# Response to Reviewer 1

**Manuscript title:** Reconstructing the Salgar 2015 Flash Flood Using Radar Retrievals and a Conceptual Modeling Framework: A Basis for a Better Flood Generating Mechanisms Discrimination

**Authors:** Nicolás Velásquez, Carlos D. Hoyos, Jaime I. Vélez, and Esneider Zapata

Figure 1: Land use in different regions of La Liboriana watershed from a 2012 satellite image.

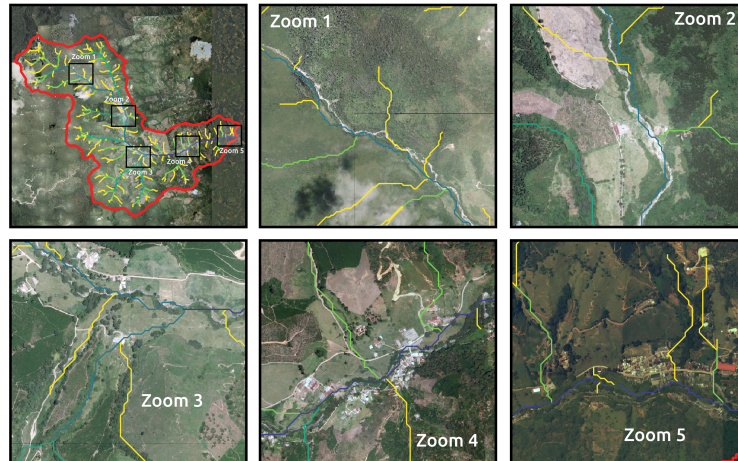
- 4.3 Pages 8-9, lines 218 – 245 : Maps of the slopes, vegetation cover (even roughly designed), and soil properties would provide a better illustration of the description.

We have added the slope map as part of Figure 2. Soil properties and vegetation cover maps are part of a national cartography with a scale of 1:400.000; at this scale there is almost no variability in the watershed. Nevertheless, we added Figure 1 showing land use in different regions of the watershed from a 2012 satellite image. According to zoom 1, the vegetation is denser in the upper region of the basin, with the presence of grass. Downstream (zoom 2), it is evident the presence of crops among forest and grass. Near the middle of the basin (zoom 3), the presence of crops is more notorious and human settlements and roads start to appear. In zoom 4, the first affected urban area from upstream to downstream, it is also possible to see a marked presence of crops and some forest patches. Finally, zoom 5 shows the main urban area of Salgar surrounded by crops, grass and an important loss of forest coverage. We modified Lines 229-234 in the original manuscript, accordingly.

Figure 2: New methodology figure.

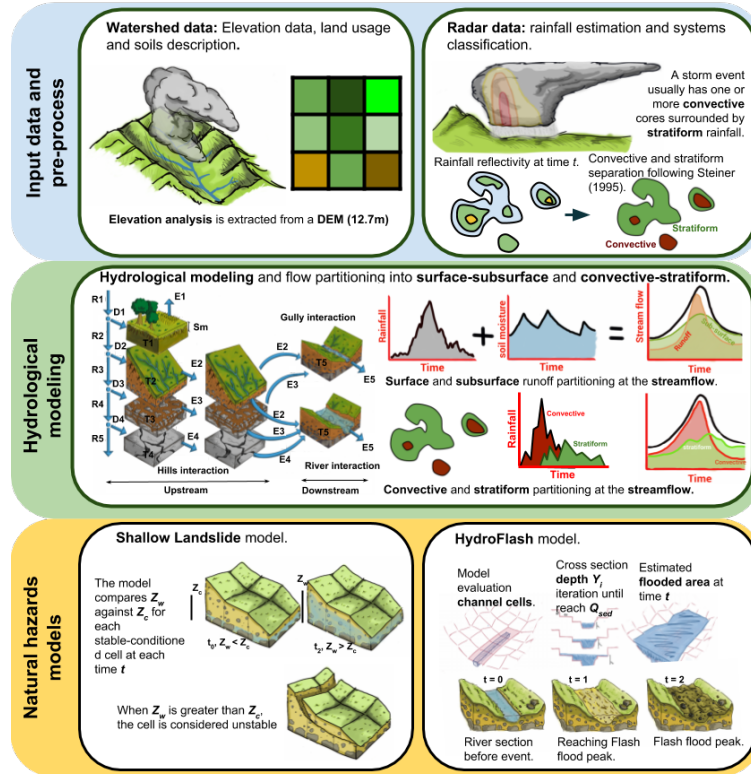
- 5.3 The Figure 5 should be the key figure offering a clear visual description of the overall method applied in this manuscript. To my understanding of the achieved work, this diagram should rather have three levels (top to down of the diagram): i) two panels showing the data inputs of the hydrological models, i.e. the DEM, the radar-based QPE, and the radar-based QPE processing according to Steiner, 1995); ii) one panel showing the hydrological model (Francés, 2007); iii) three panels showing the 3 results of the overall methods : the discharge simulation with water origins and paths information, the landslides submodel, and finally the flood plain assessment.

T9 Figure 5: we can't read any legend of the hydrological model, please uniform the size of the annotation in this figure.

We changed Figure 5 according to the reviewer suggestions and we think it offers now a clearer picture of the work. See Figure 2 in this document.

The Figure was edited; please see Figure 2.

Figure 3: Edited figure.

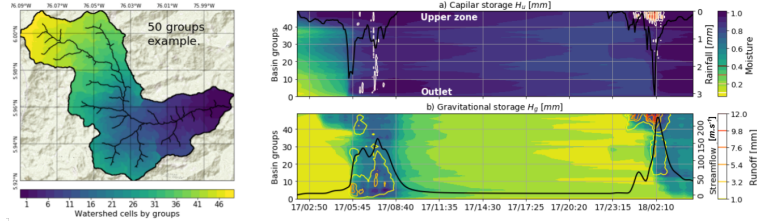
T15 Figure 9 and 10: These figure 9 and 10 might be merged, presenting on the left side the 50 groups categorization (right panel of the figure 9), and the current figure 10 on the right side. The same key color defining the 50 groups categorization should be used in the map (Fig. 9) and to define somehow the related scale of the fig. 10.

In the Figure 3 we present how Figure 9 and 10 were merged in the revised document.
